Access Compliance Report

Public Rights-of-Way

Intersection ID: 24913	Main Street: HUGH_FOREST_RD	Cross Street: SYDNEY_DR	Location: NW
ADA ID: E2A7DC634B11	Ramp Type: Perp	Initial Pass/Fail: Fail	Overall Compliance: No
		Severity Score: 25

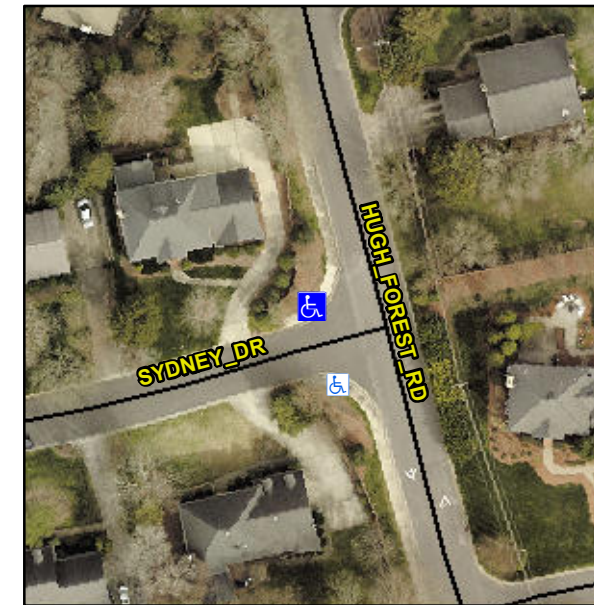
Not Found, R304.2.2

Compliance	Description	Data	Compliance	Description	Data
N/A	Ramp Length (in)	62.5	No	Ramp Slope (%)	15.0
Yes	Ramp Width (in)	48.0	Yes	Ramp XSlope (%)	1.1
N/A	Flare Type LT	N/A	N/A	Flare Type RT	N/A
N/A	Flare Slope LT (%)	N/A	N/A	Flare Slope RT (%)	N/A
N/A	Flare Traversable LT?	N/A	N/A	Flare Traversable RT?	N/A
N/A	Landing Length (in)	N/A	N/A	DWS Provided?	N/A
N/A	Landing Width (in)	N/A	N/A	DWS Contrast?	N/A
N/A	Landing Slope (%)	N/A	N/A	DWS Length (in)	N/A
N/A	Landing X Slope (%)	N/A	N/A	DWS Full Width?	N/A
N/A	Landing Curb? (Y/N)	N/A	N/A	DWS Offset (in)	N/A
N/A	Shared Landing?	N/A			
N/A	Gutter Ponding?	N/A	N/A	Gutter Slope (%)	N/A
N/A	Gutter Lip Ht (in)	N/A	N/A	Gutter X Slope (%)	N/A
N/A	Painted X Walk1?	No	N/A	Painted X Walk2?	N/A
	X Walk 1 Direction	To S		X Walk 2 Direction	N/A
N/A	X Walk 1 Width (in)	N/A	N/A	X Walk 2 Width (in)	N/A
	X Walk 1 Slope (%)	0.3		X Walk 2 Slope (%)	N/A
	X Walk 1 X Slope (%)	2.2		X Walk 2 X Slope (%)	N/A

Remove & Replace Entire Ramp.
